Sewerage & Water Board OF NEW ORLEANS

Addendum No. 3

Your reference is directed to **Contract Number: 2024-SWB-97** for Grid Control System which is scheduled to open at **11:00 a.m. CST on January 07, 2025** for SWBNO Engineering Department.

SEWERAGE AND WATER BOARD OF NEW ORLEANS
CONTRACT No. 1369
HMGP EMERGENCY FUEL STORAGE RETROFIT POWER PLANT
MAIN WATER PURIFICATION PLANT POWER COMPLEX
MCC-3 & G5 ONE LINE DIAGRAMS & EQUIPMENT LAYOUT

MCC-3
1 ELEVATION
SCALE: 3/4"=1'-0"

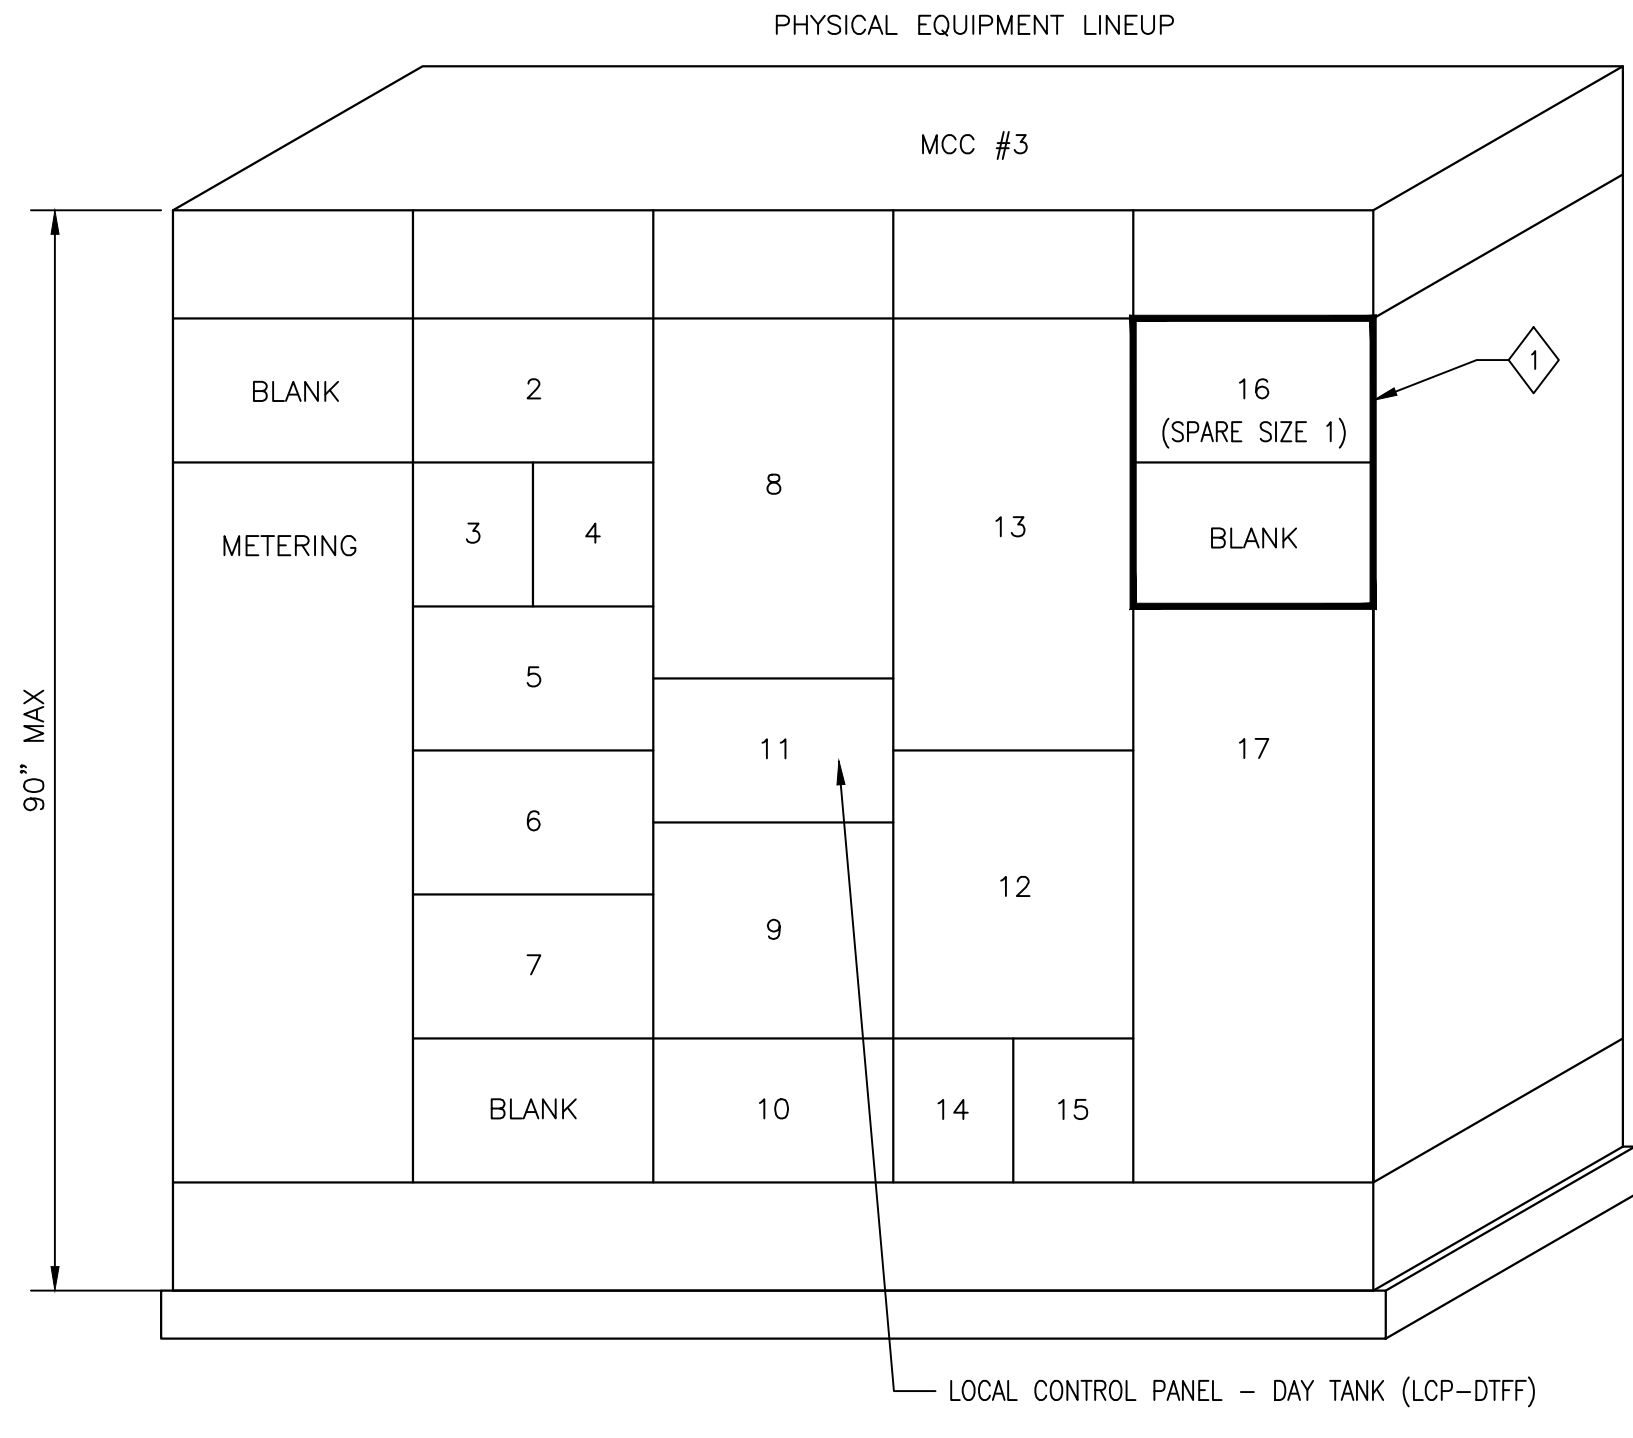
VFD REPLACED BY FOAM BOOSTER PUMP STARTER DUE TO ALTERNATE FEED, ADDRESSED VIA RFI-0067. THE FOAM BOOSTER PUMP SCHEMATIC, SUL-0244A PROVIDED AS HAND-SKETCHED AS-BUILT BY CONTRACTOR. THE FOAM BOOSTER PUMP STARTER IS NOW FED FROM MCC-G3 AND FUSED ACCORDING TO THE MOTOR SPECIFICATIONS.
